- 1. Project Name: Laupahoehoe Navigational Improvements
- 2. Date of Inspection: May 6, 2005
- 3. <u>Inspection Personnel</u>:

4. Discussion:

The inspected portion of the project consists of a 60 linear foot (LF) wave absorber and a 200 LF concrete armor unit breakwater. The following are deficiencies noted during the inspection:

a. Sta. 0+00, Oceanside (OS), Overview of breakwater.

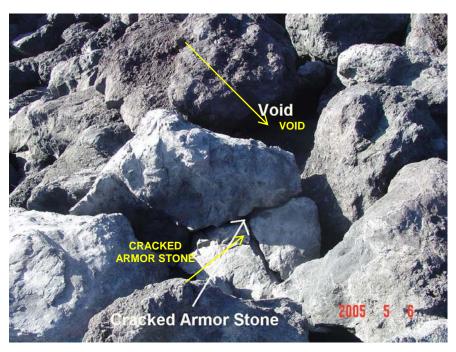
b. Sta. 0+30, HS, Remove tree from armor stones.

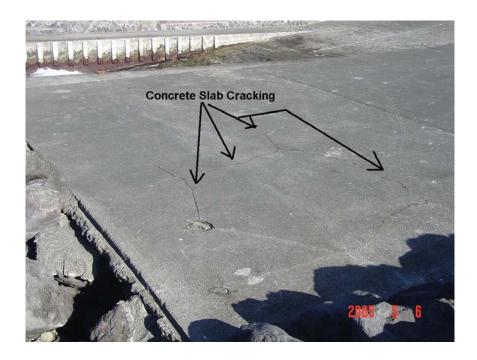
There has been a loss of underlayer material in the cells of the rib cap between the ribs and beams. The typical section depicts two layers of 5 to 7 ton stone directly below the concrete cap and 1 to 3 ton stone underneath. Apparently, the specified stones were replaced with greatly undersized stone during construction. The undersized stone is slowly being washed away, creating a more porous structure that allows more energy into the harbor, and could ultimately threaten the stability of the breakwater.

d. ReBar exposed, left side of poured-in-place slab.

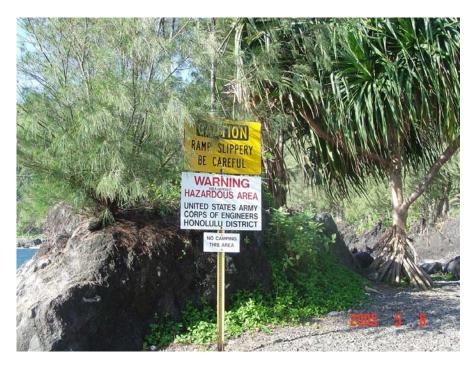
c. Boat Ramp Concrete erosion up to 3 inches.

COMMENT: BOAT RAMP - The precast trapezoidal concrete slab (w/1 inch groves ribs) originally installed outlasted the cast-in-place broom finished slab. Small stones in the boat ramp's surf zone have accelerated the erosion of the tremie concrete.
